AUBURN CITYCOUNCIL

JRPP Report

41-45 Hill Road, WENTWORTH POINT

DA-309/2010/B GF:ML

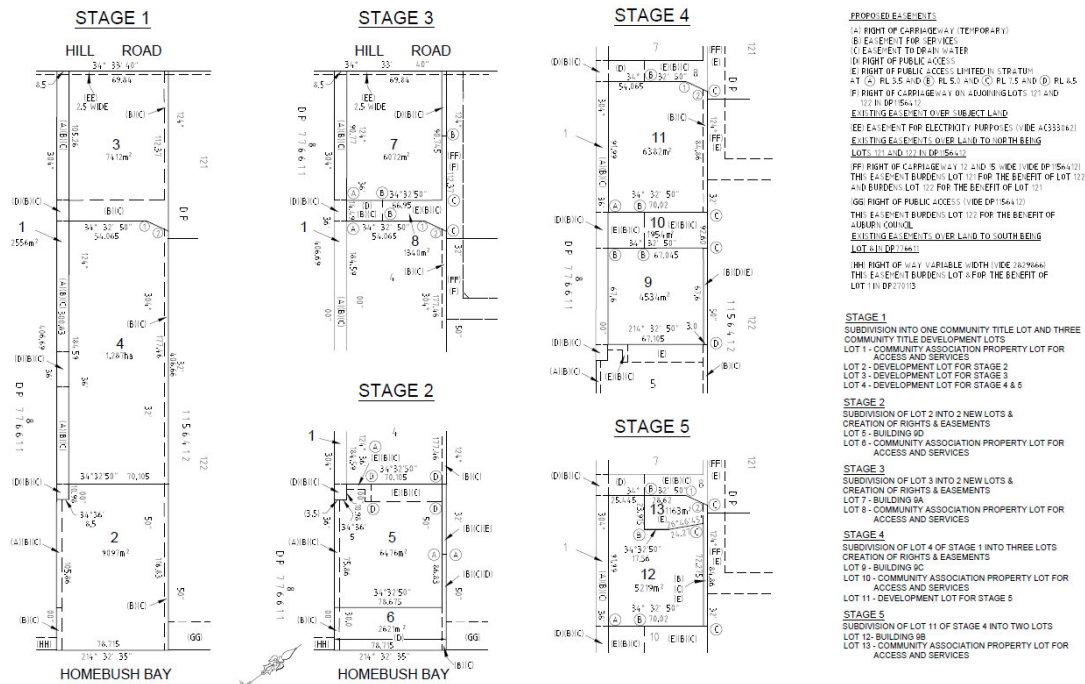
Development application for civil infrastructure works across Lot 9 which will comprise, roads (road works), footpaths, stormwater drainage and utility service infrastructure. The development application also includes landscaping of the public domain area across Lot 9. This application is currently under assessment by Council and is an amendment to the original approval under DA462/2010 to reflect and synchronise with changes proposed under the subject modification. This amendment will ensure that development consent exists for the works necessary to provide vehicle access to Block C. *(it is noted that works associated with DA-462/2010/A are to be carried out in stages).*

SEE amended “indicative” staging plan below.
